Acceptance and approval of the AIA Document A101 form of Agreement between Hidalgo County (Owner) and **JCon Construction, LLC** awarded contractor in the amount of **$1,350,000.00** for **Project: Hidalgo County Precinct No. 4 Construction of the Linn - San Manuel Emergency Services Facility (Contract No. C-14-067-06-03);**

Hidalgo County Precinct No. 4
Linn – San Manuel Emergency Services Facility
2014-067-04-02-MSS-Hidalgo County Precinct No. 4
"Construction of the Linn – San Manuel Emergency Services Facility"

ADDENDUM No. 1

March 26, 2014

Date: 3-26-14	TITLE: CMU WALL/METAL STUD LAYOUT NOTES
Project No.: 13227	REVISION: 1 3-26-14
Drawn by: L.R.	PAGE: ADD.#1/S1
Checked By: MC	
SCALE: NTS

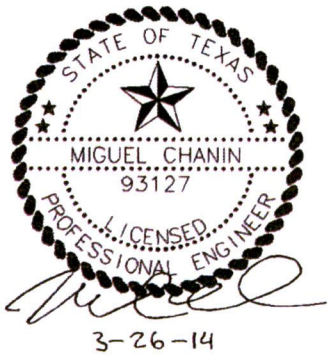
A. Revisions to Sheet S4.0 as noted.

CMU WALL / STUD WALL LAYOUT NOTES:

2. FOR TYPICAL CMU WALL CONSTRUCTION SEE SHEET S2.2.
3. ▬▬ INDICATES EXTERIOR 8" CMU WALL WITH #5 (V) AT 48" O.C. AND #5 (H) AT 8'-0" O.C., U.N.O. (1)
4. ▨ INDICATES EXTERIOR 12" CMU WALL WITH (2) #5 (V) AT 32" O.C. AND (2) #5 (H) AT 8'-0" O.C., U.N.O.
